**IN THE MATTER Resource Consent Applications by Northport Ltd – Port Expansion Project at Marsden Point.**

**JOINT WITNESS STATEMENT (JWS) IN RELATION TO:**

**STORMWATER, GROUNDWATER and PLANNING**

**6 May 2024**

Figure 1. Pond water balance summary.

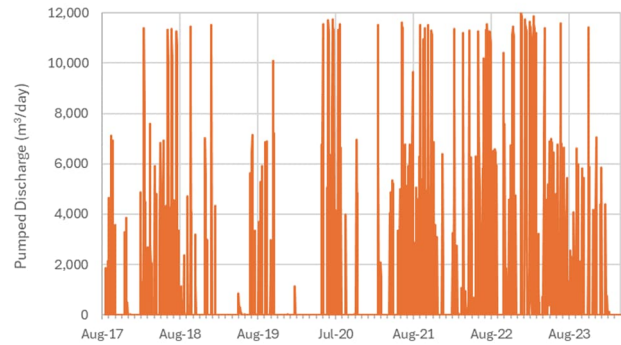
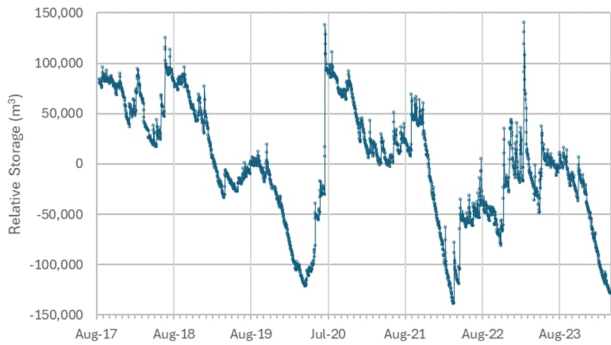
Q#	Query	Response
		<p>conductivity of the materials under the pond of <math>4.6 \times 10^{-8}</math> m/s (assuming a 1 m head), which is a low permeability value.</p> <p>Based on the calculation performed, the estimate average seepage rate is <u>approximately 400 m<sup>3</sup>/day</u>. In practice, the seepage rate will be governed by head dependent, hence it will increase during periods where pond water levels significantly exceed groundwater and vice versa. I expect high seepage to coincide with winter conditions and vice versa.</p> <p>In comparison, the maximum <u>pumped discharge</u> is just under <u>12,000 m<sup>3</sup>/day</u>.</p>
